CERTIFICATE OF THE SECRETARY OF ENERGY AND ENVIRONMENTAL AFFAIRS
ON THE
FINAL ENVIRONMENTAL IMPACT REPORT

PROJECT NAME : Waltham High School
PROJECT MUNICIPALITY : Waltham
PROJECT WATERSHED : Charles
EEA NUMBER : 16097
PROJECT PROPONENT : City of Waltham
DATE NOTICED IN MONITOR : August 26, 2020

Greenway Plan

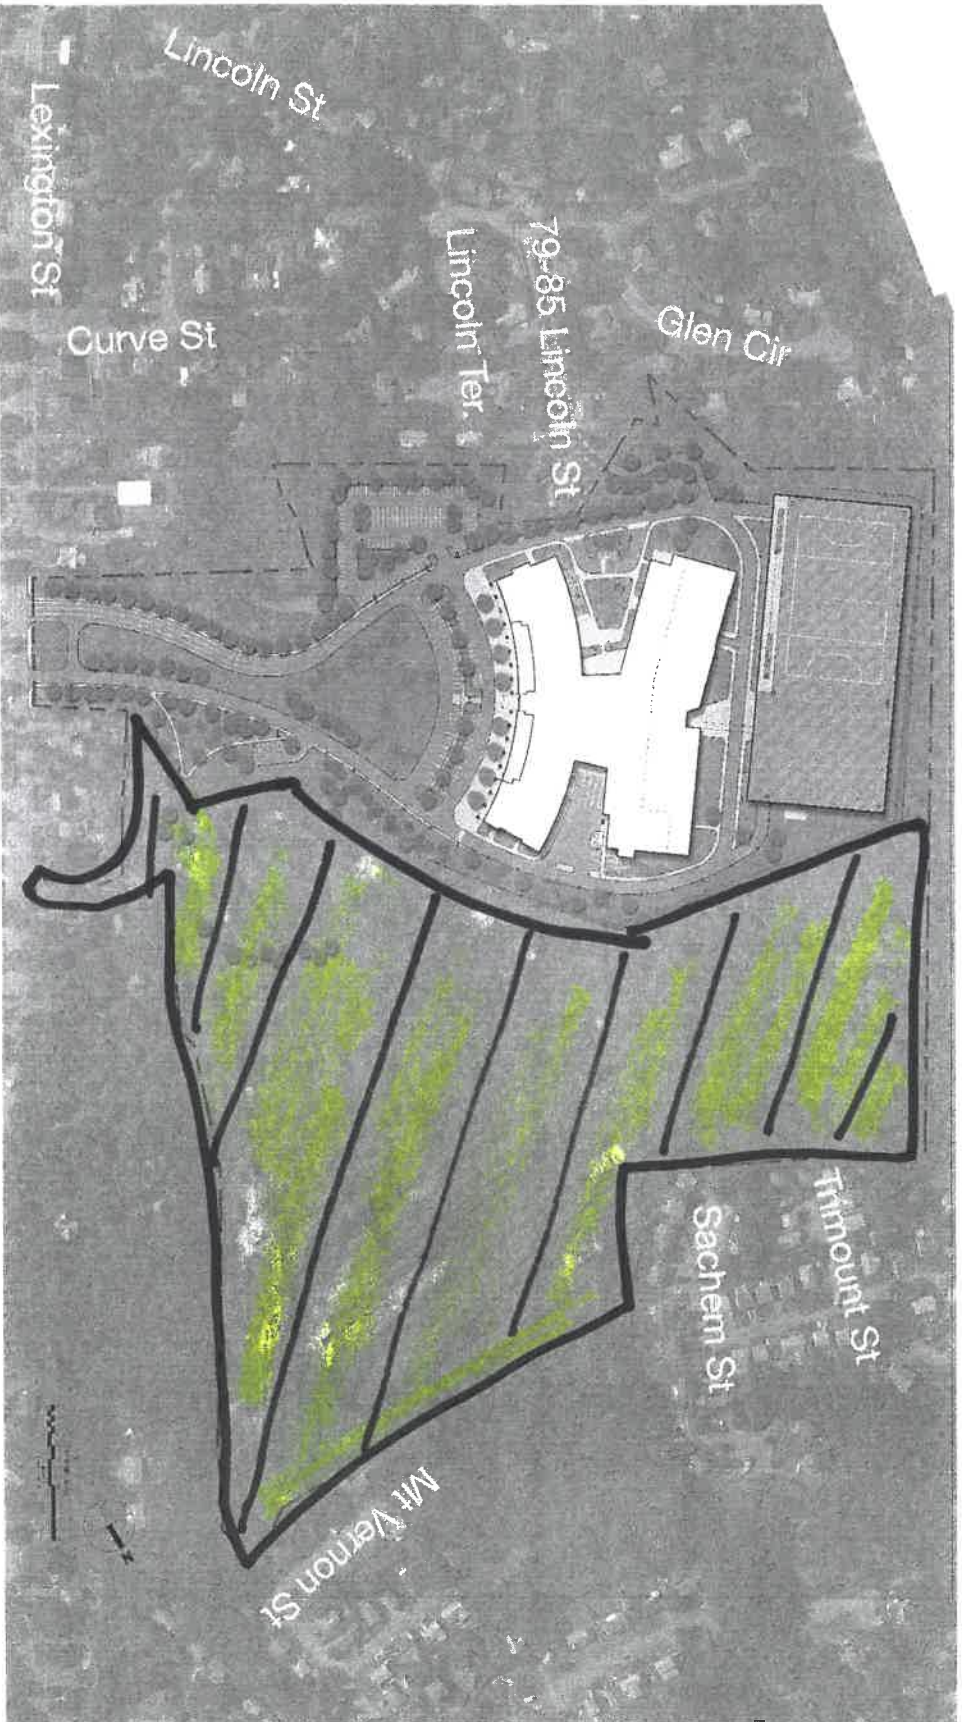
I have reviewed the final environmental report and would state that I support the City of Waltham's latest plans dated July 2020 as this plan minimizes the environmental impact to this land. As previously stated in order to truly limit the Environmental impact on this site the state should require the City to place Conservation Restrictions on the undeveloped portion of the site or require that if in the future the City of Waltham plans on modifying this plan for the site they are required again to file an Environmental Impact Report and be subject to the same standard. In the future if the City were to expand the plan and build on the undeveloped area they would be required again to prove that the new plan has the least environmental impact on the land.

Leaving a legacy of continuous open space which supports a vibrant ecosystem and wildlife habitat throughout the City of Waltham. Again I would urge that the state make this Conservation Restriction part of the MEPA final certification. (See proposed plan of the restricted area attached)

Alternate Jericho Site Plan

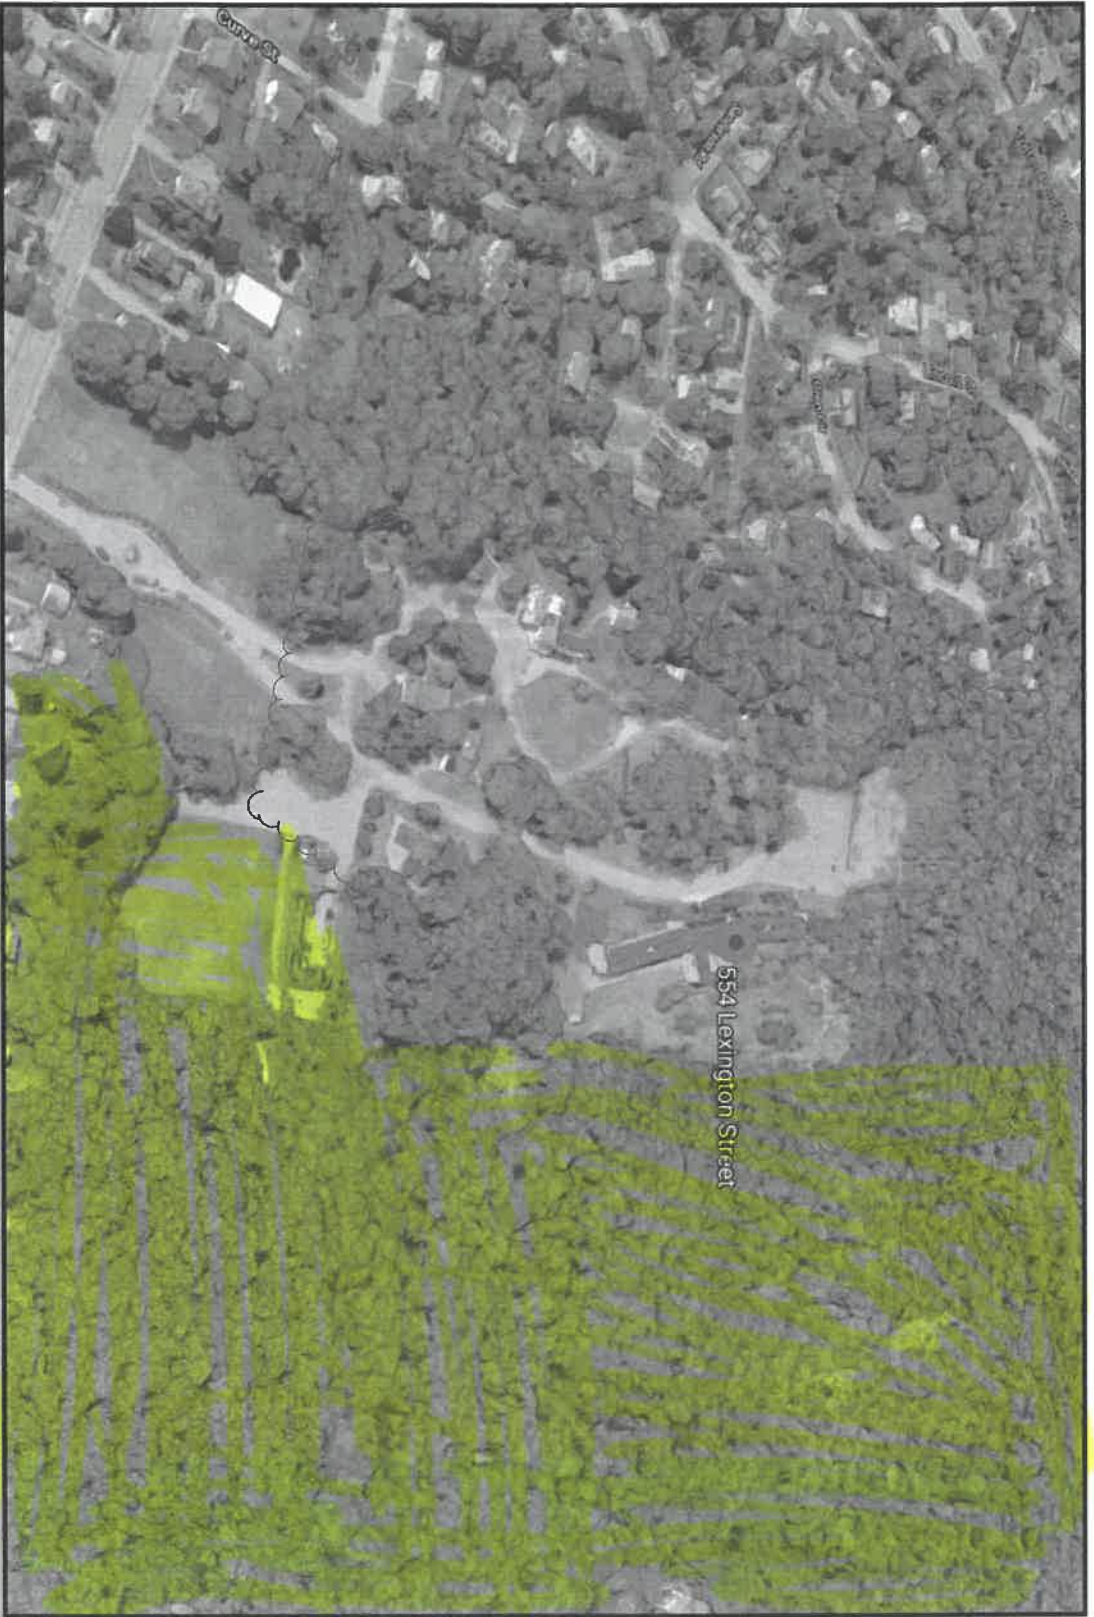
In support of this protection I would state that the City of Waltham beginning in 1990 developed a Greenway plan to connect various open space parcels from the Town of Belmont line to Prospect Hill. This parcel at 554 Lexington St., the newly added 6 acre parcel known as Jericho Hill and Sanderson Heights are part of this Greenway plan. The City of Waltham's proposed site plan accompanying this filing does in fact carve out an area to complete the Greenway plan. With the requirement of placing a Conservation Restriction on 554 Lexington and on the undeveloped area of Jericho Hill as well as Sanderson Heights, the City will in fact complete the Waltham Greenway.
